# LANDON PARK APARTMENTS REDEVELOPMENT PLAN

MYLAR CHANGE TO UPDATE  
SHEETS 7 THROUGH 10 (6/13/17)

RE-DEVELOPMENT PLAN COVER SHEET  
LANDON PARK APARTMENTS  
AT AURORA CENTER SUBDIVISION FILING NUMBER 1  
100 SOUTH SABLE BOULEVARD  
AURORA, COLORADO 80012

# REDEVELOPMENT PLAN LANDON PARK APARTMENTS LANDSCAPE PLAN

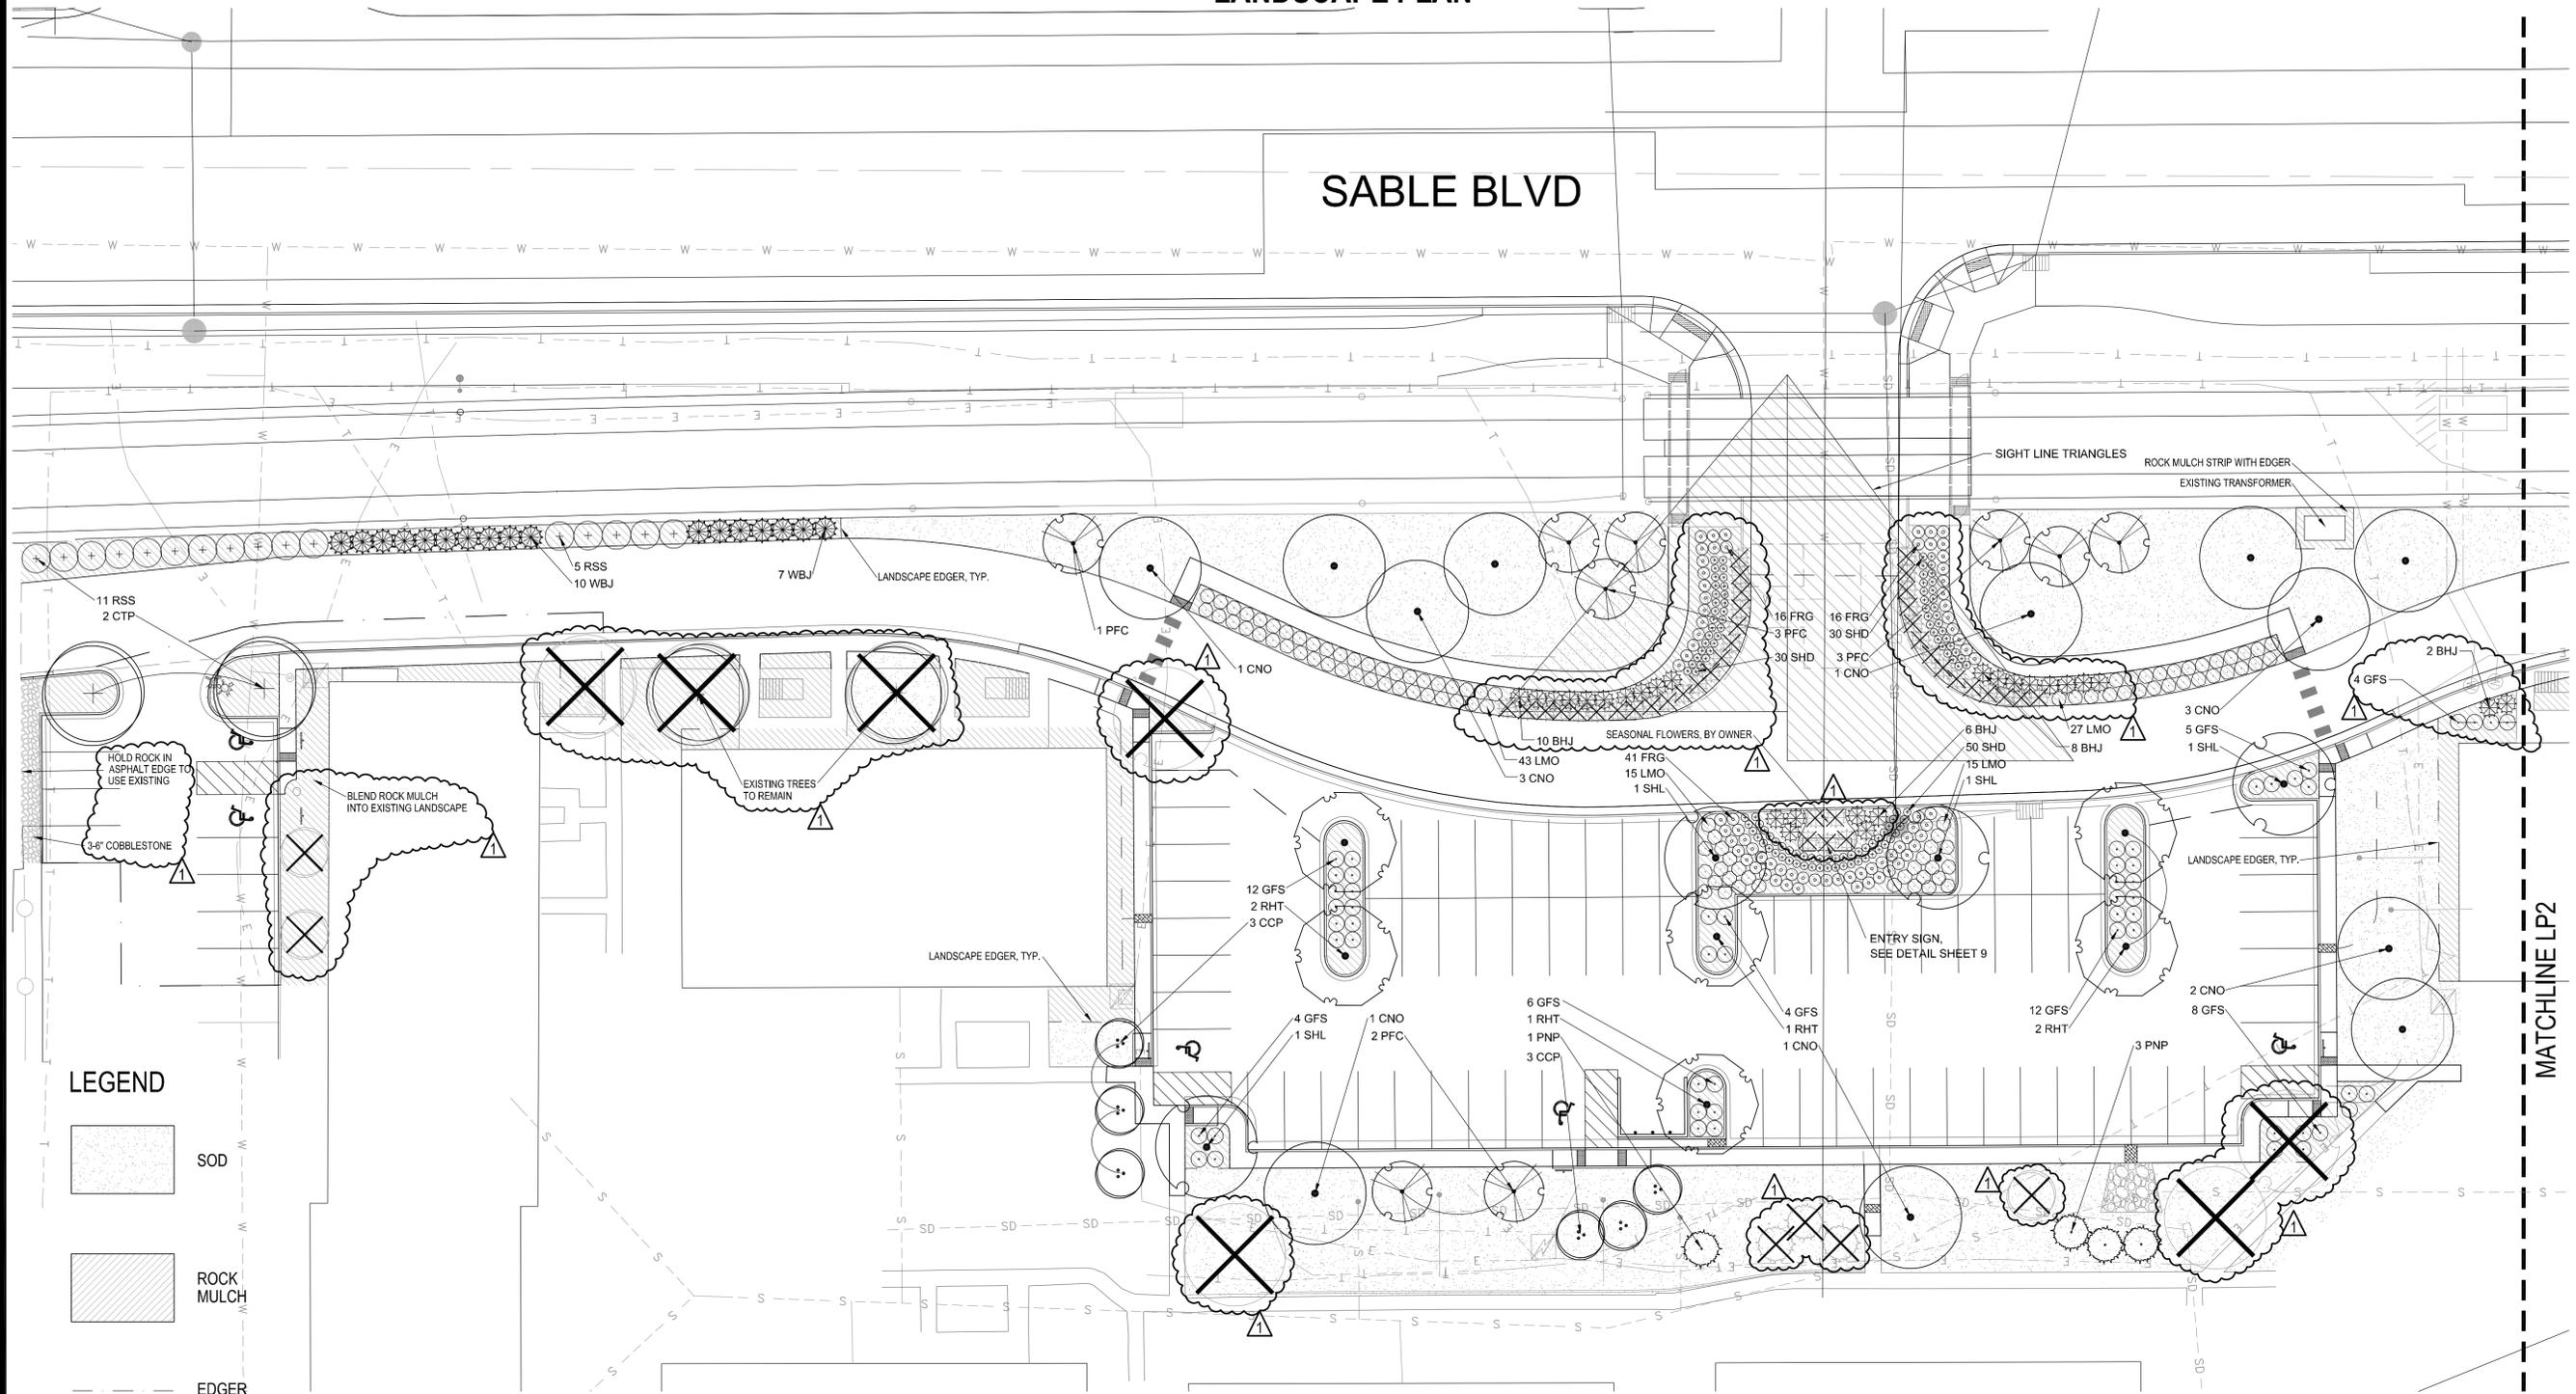
- ORIGINALLY PROPOSED TREE REMOVED
- CHANGE FROM ORIGINAL DESIGN

ALL CHANGES FROM THE ORIGINAL SUBMITTAL ARE DUE TO EXISTING SITE CONDITIONS AND CONSTRAINTS.

# REDEVELOPMENT PLAN LONDON PARK APARTMENTS LANDSCAPE PLAN

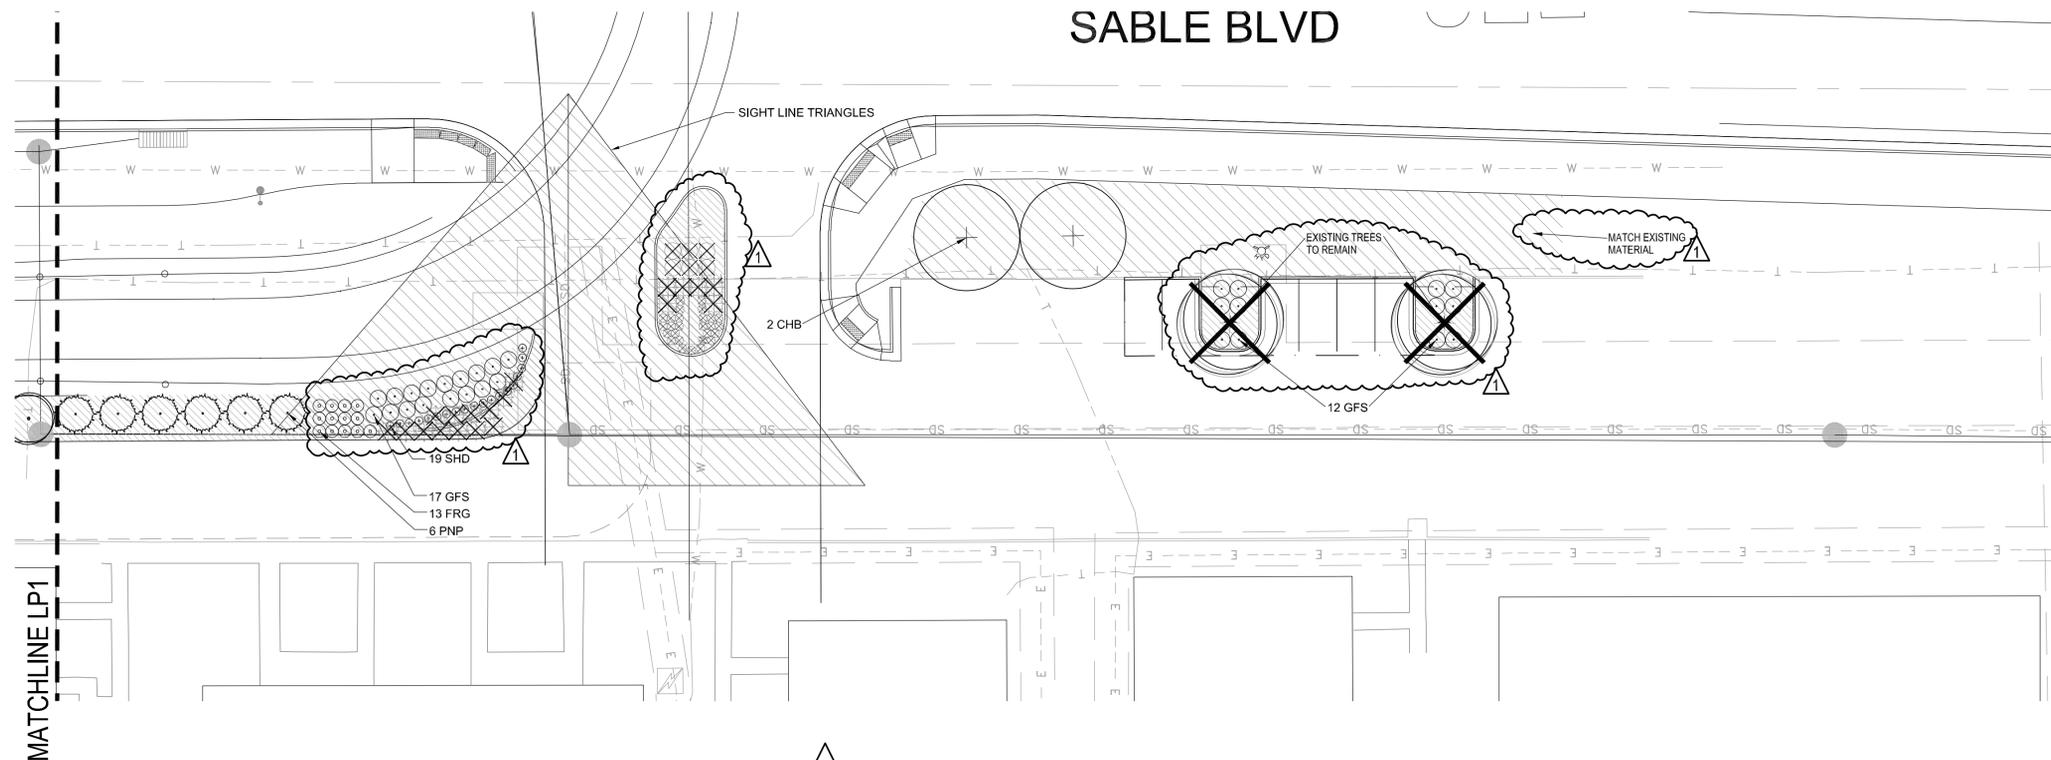
1 ALL CHANGES FROM THE ORIGINAL SUBMITTAL ARE DUE TO EXISTING SITE CONDITIONS AND CONSTRAINTS.
